RE: Volcano Heights Marketplace
Conceptual Grading Plan and Conceptual Drainage Report
Stamp Date: 6/14/17
Hydrology File: C10D002

Based upon the information provided in your submittal received 6/16/2017, the Conceptual Grading Plan and Conceptual Drainage Report **is not** approved for Site Plan for Subdivision and Site Plan for Building Permit. The following comments need to be addressed for approval of the above referenced project:

Volcano Heights Marketplace

Conceptual Drainage Report

SHEET NO.
6

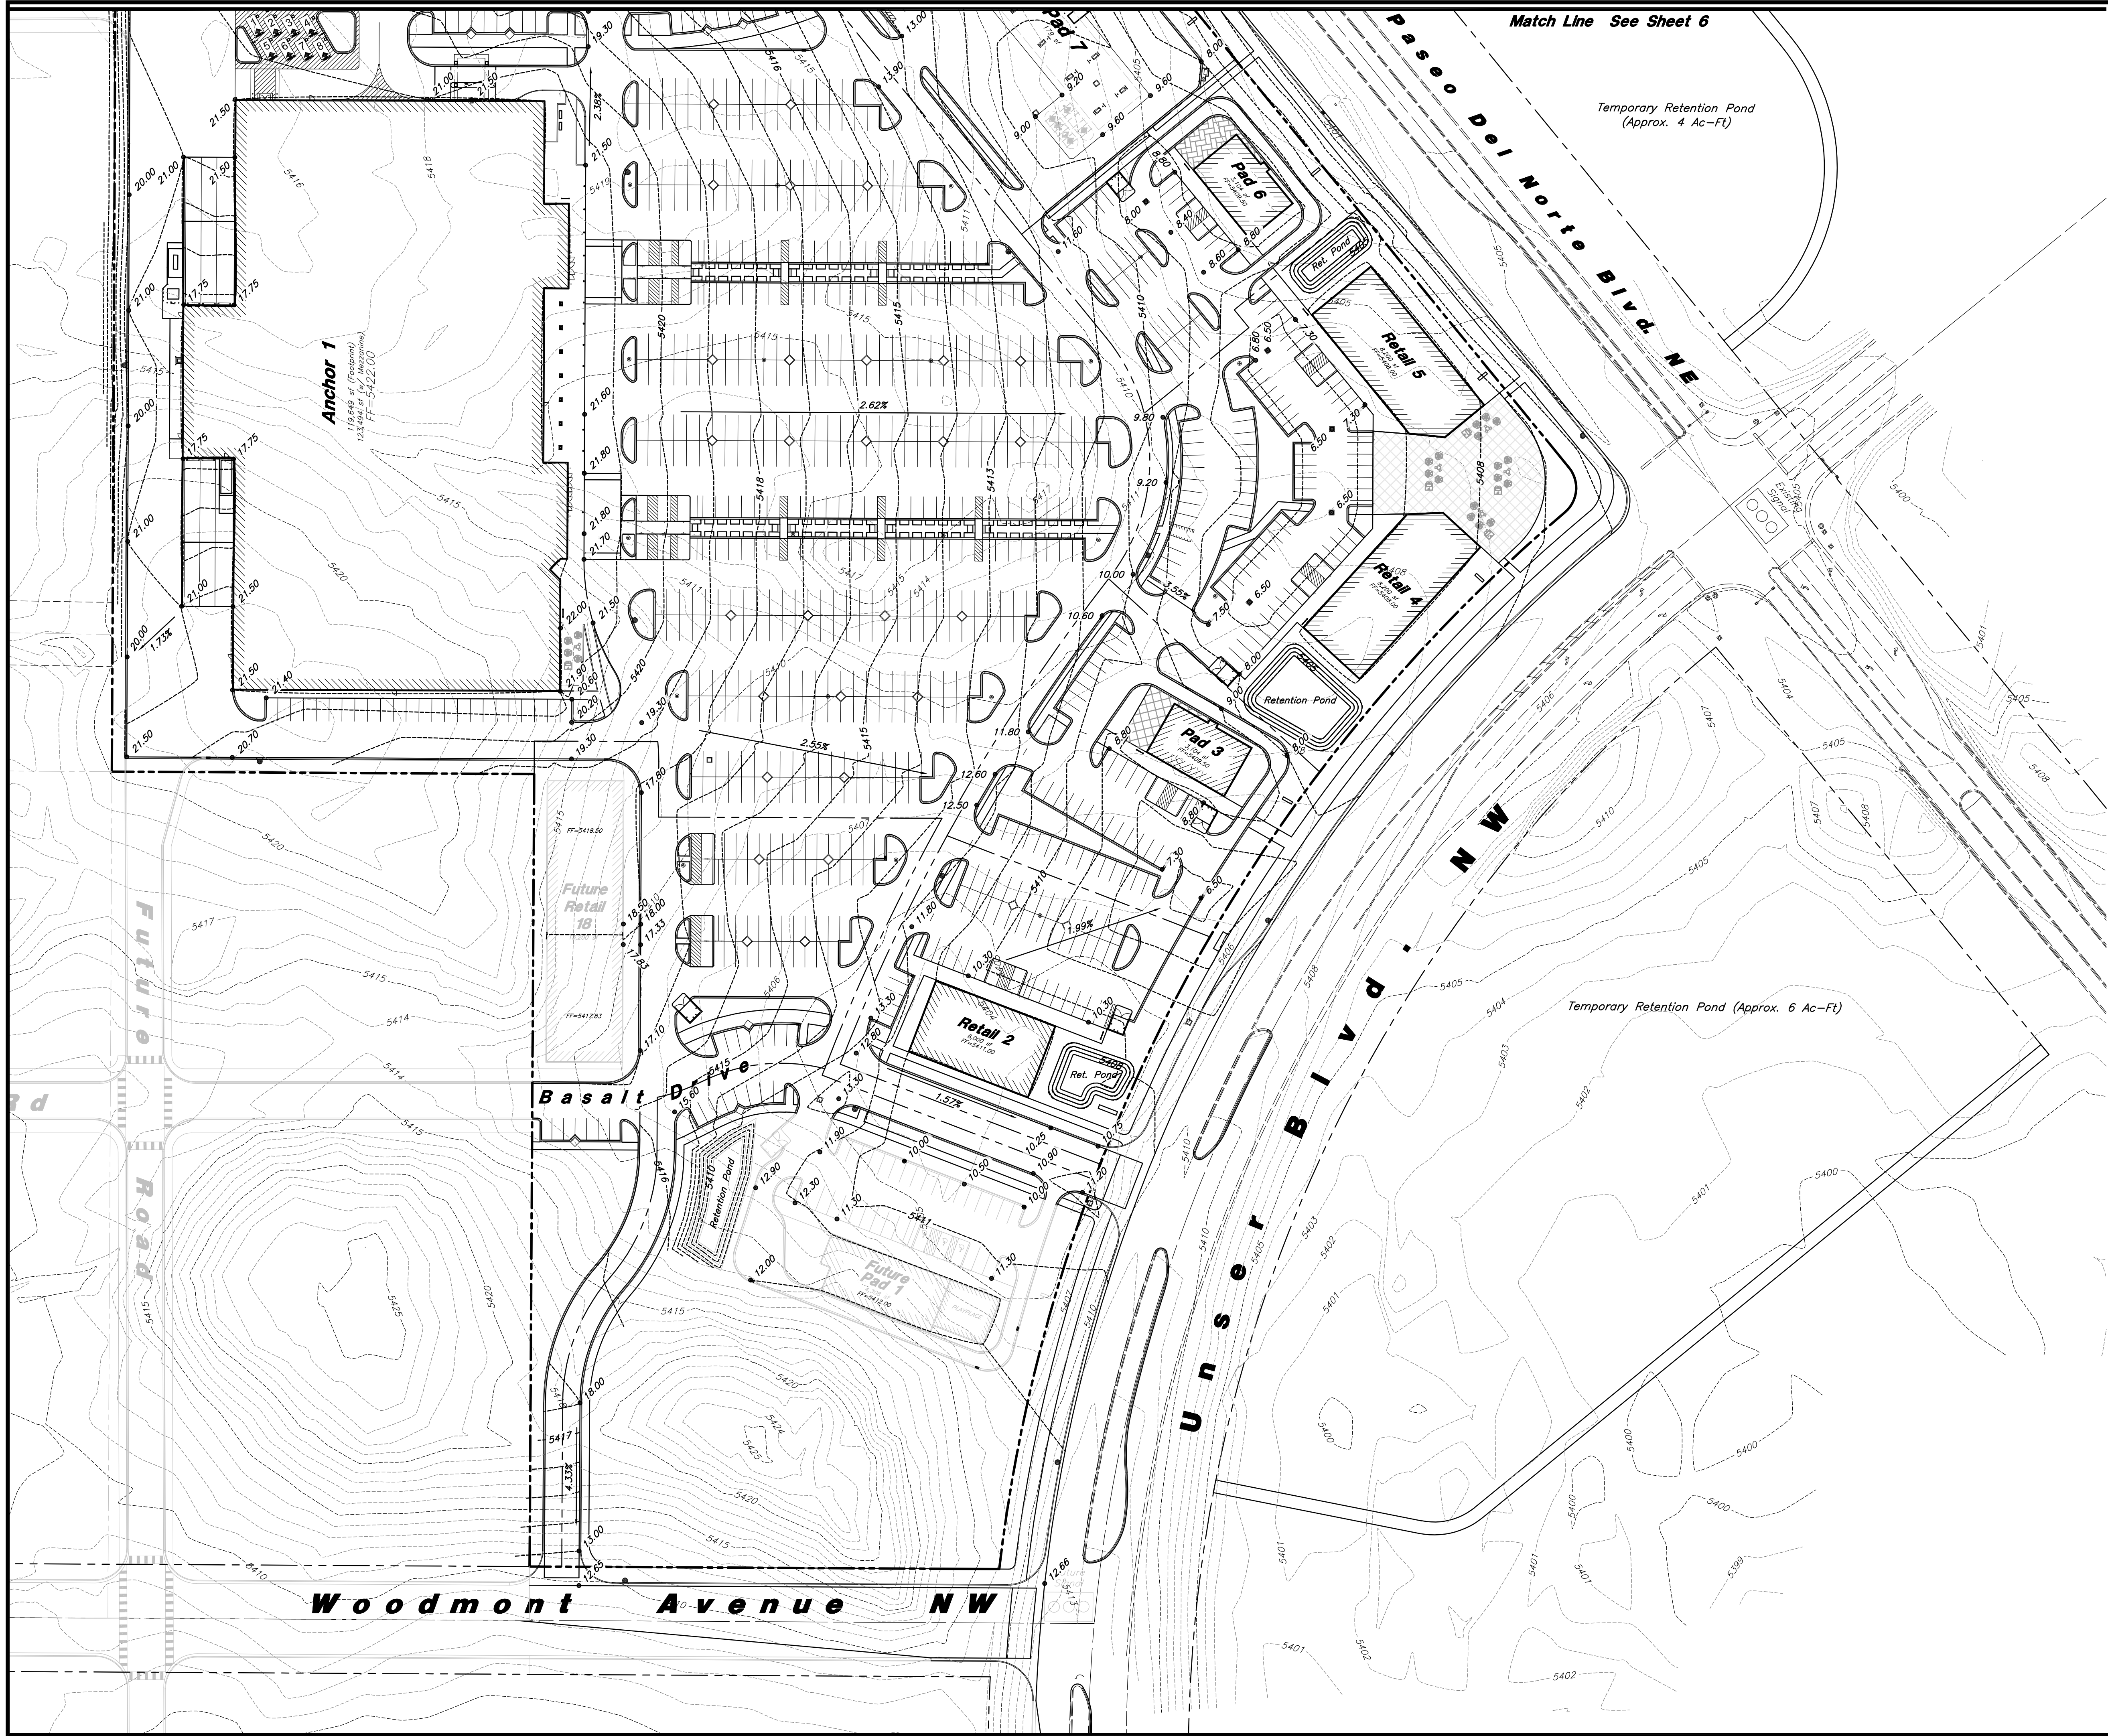
1. On Sheet 6 & 7. Please add the work "**Conceptual**" to the sheets title.
2. On Sheet 6 & 7. Please sign and date the engineer's stamp.
3. On Sheet 6 & 7. Please add a note stating "**Not for Construction**".
4. Please provide a Private Facility Drainage Covenant and Reservation of Private Drainage Easement per Chapter 17 of the DPM.
5. Please show Cross Lot Drainage Easements on both the Plat and the Grading & Drainage Plan specifying the beneficiary and maintenance agreement.

14 Jun, 2017
SHEET NO.
8

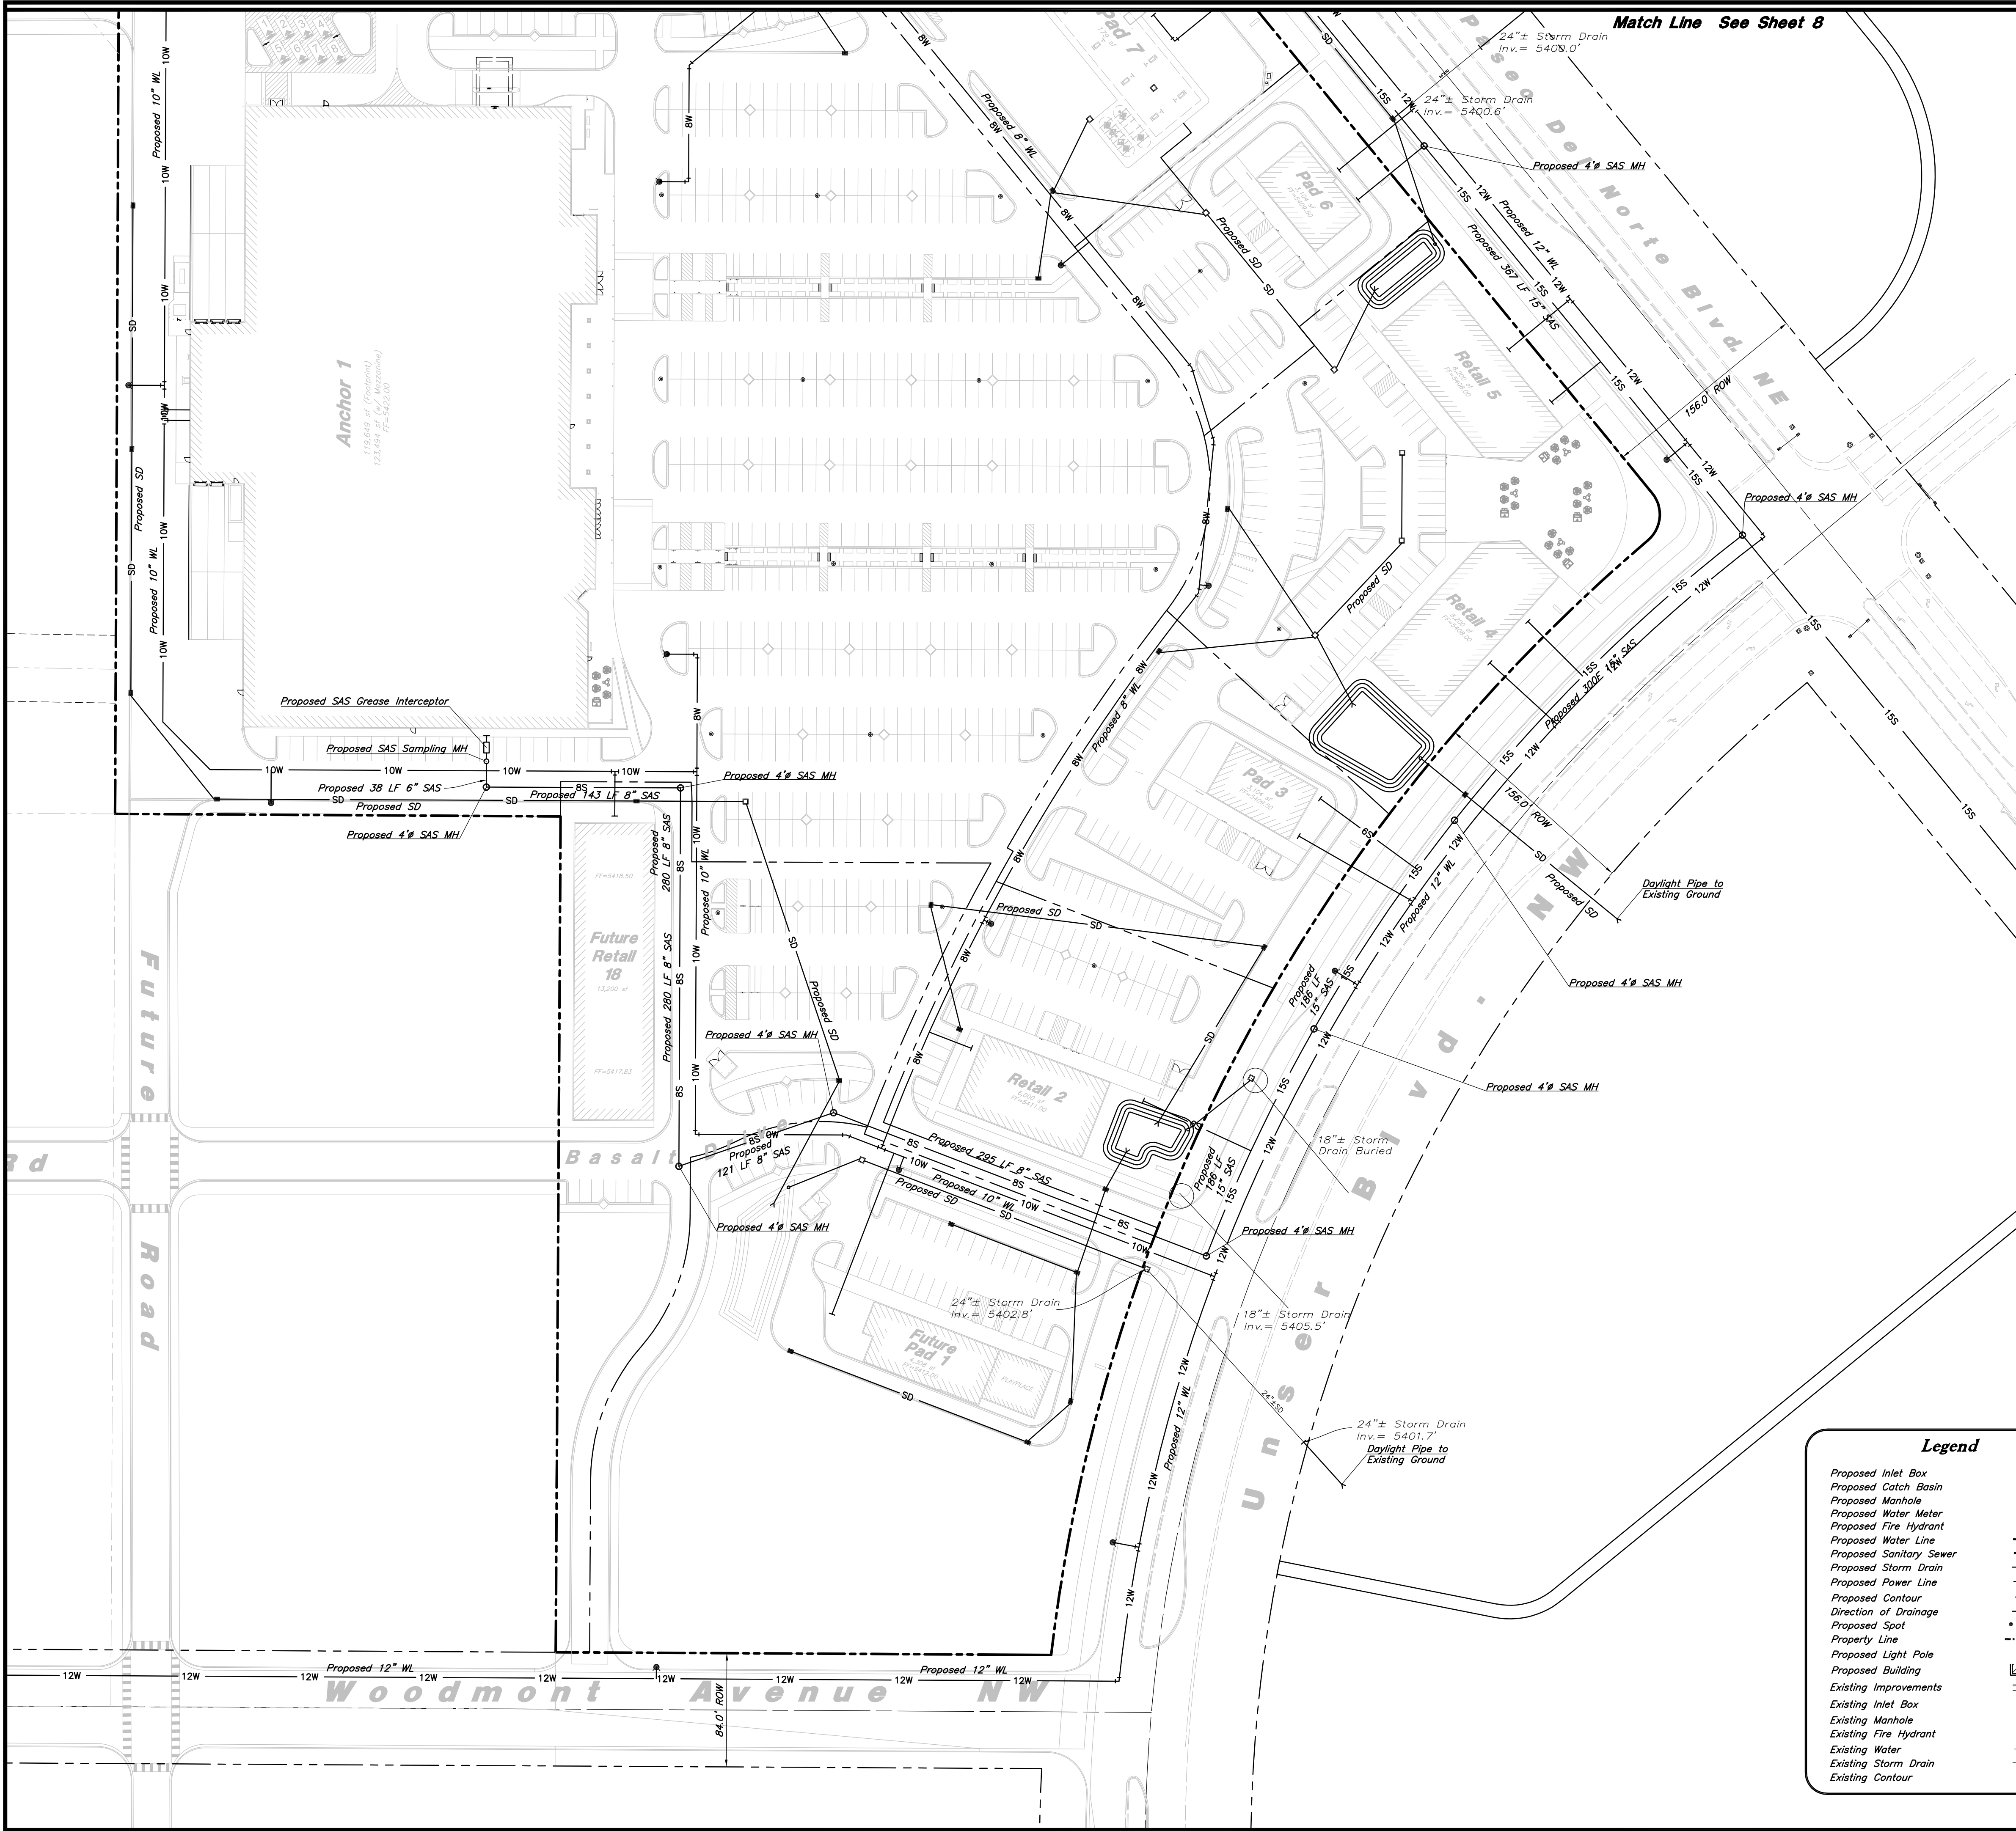
1. On Sheet 8 & 9. Please add the work "**Conceptual**" to the sheets title.
2. On Sheet 8 & 9. Please sign and date the engineer's stamp.
3. On Sheet 8 & 9. Please add a note stating "**Not for Construction**".

4. On Sheet 8 & 9. Utilizing the inlet locations from note #2, the permanent storm pipe system needs to be laid out.
5. Since the downstream storm pipe system is not installed, the proposed temporary retention ponds are needed per your design. However, the permanent storm pipe system needs to be utilized to convey the storm runoff into those temporary retention ponds. At the junction for the outfall into those ponds, a plug will be placed at the outlet for the permanent storm pipe system. In the future and once the downstream storm pipe system is built, the plugs will be removed, the storm pipes to the ponds plugged and the pipe removed and the temporary retention ponds filled in.
